Baltimore County Public Schools

DATE: 7-5-14	THIRD PARTY: RADCO 5801 BENJAMIN CENTER, SUITE 102 TAMPA, FLORIDA 33634 813-243-0370	BY: J.B.
SCALE: NTS	REVISIONS: (CONNECT 3-WAY SWITCHED LIGHTING W/ONE CIRCUIT) 7-10-14	SHEET
CODES: SEE NOTES	STATES: VA, MD.	
TMS 576 24 x 36 EDUCATION R-1		
COVER SHEET		DESTINATION: BALTIMORE CO.
		1 OF 5

TITAN MODULAR SYSTEMS, INC.			
162 INDUSTRIAL DRIVE 912-632-3344 (PH)		ALMA, GA. 31510 912-632-3345 (FX)	
DATE: 7-5-14	THIRD PARTY: RADCO	5801 BENJAMIN CENTER, SUITE 102 TAMPA, FLORIDA 33634 813-243-0370	
SCALE: 3/16"=1'-0"	REVISIONS:	CONNECT 3-WAY SWITCHED LIGHTING W/ONE CIRCUIT	BY: J.B.
CODES: SEE NOTES	STATES: VA, MD.	TMS 576 24 x 36 EDUCATION R-1	SHEET 2 OF 5
FLOOR PLAN		DESTINATION: BALTIMORE CO.

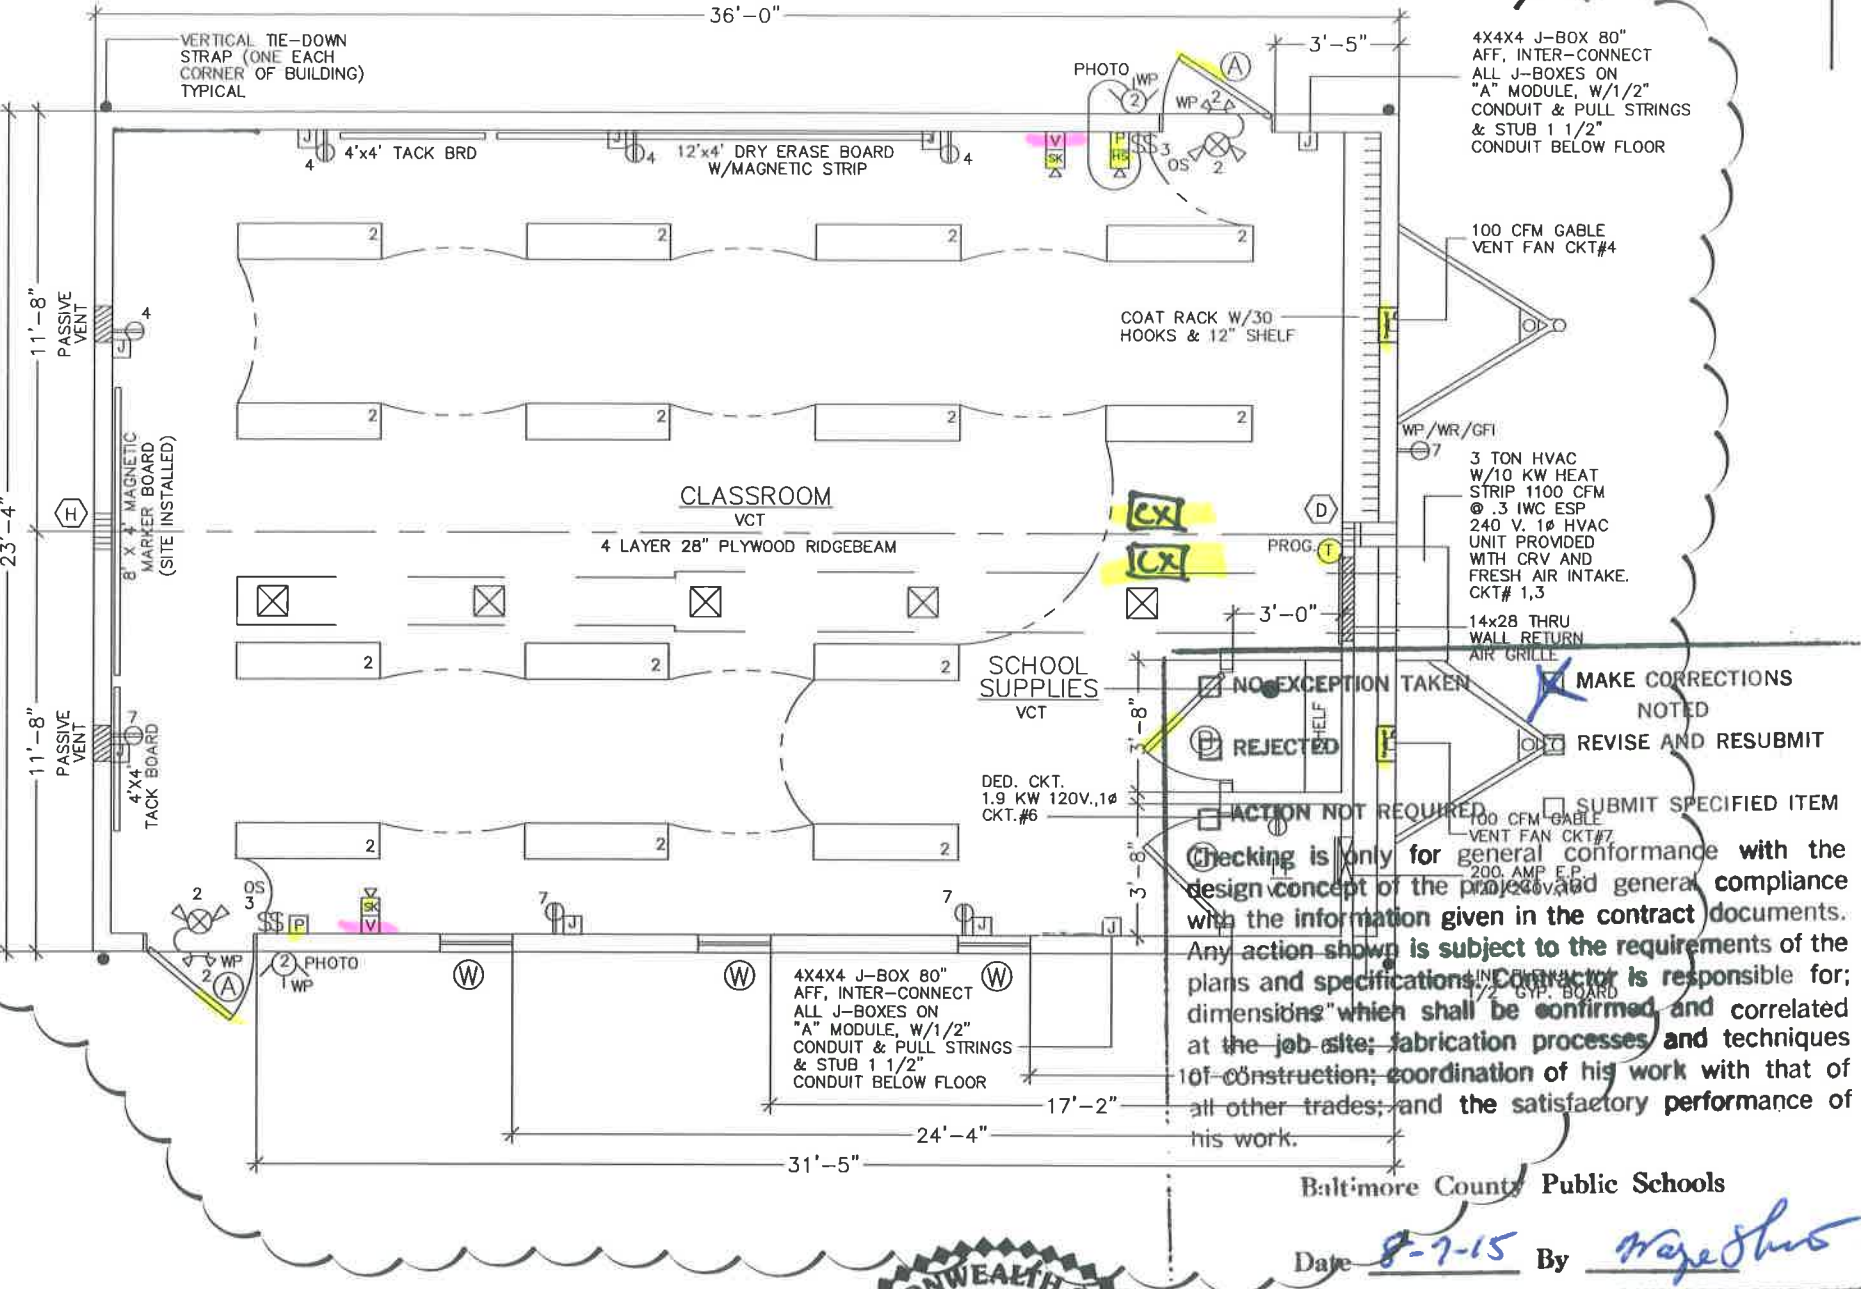
Bcps notes

- eliminate
- note location
- Dry erase boards to have 1" tack rail

Bcps note

A exterior door and **B** closet door locks to be keyed alike.
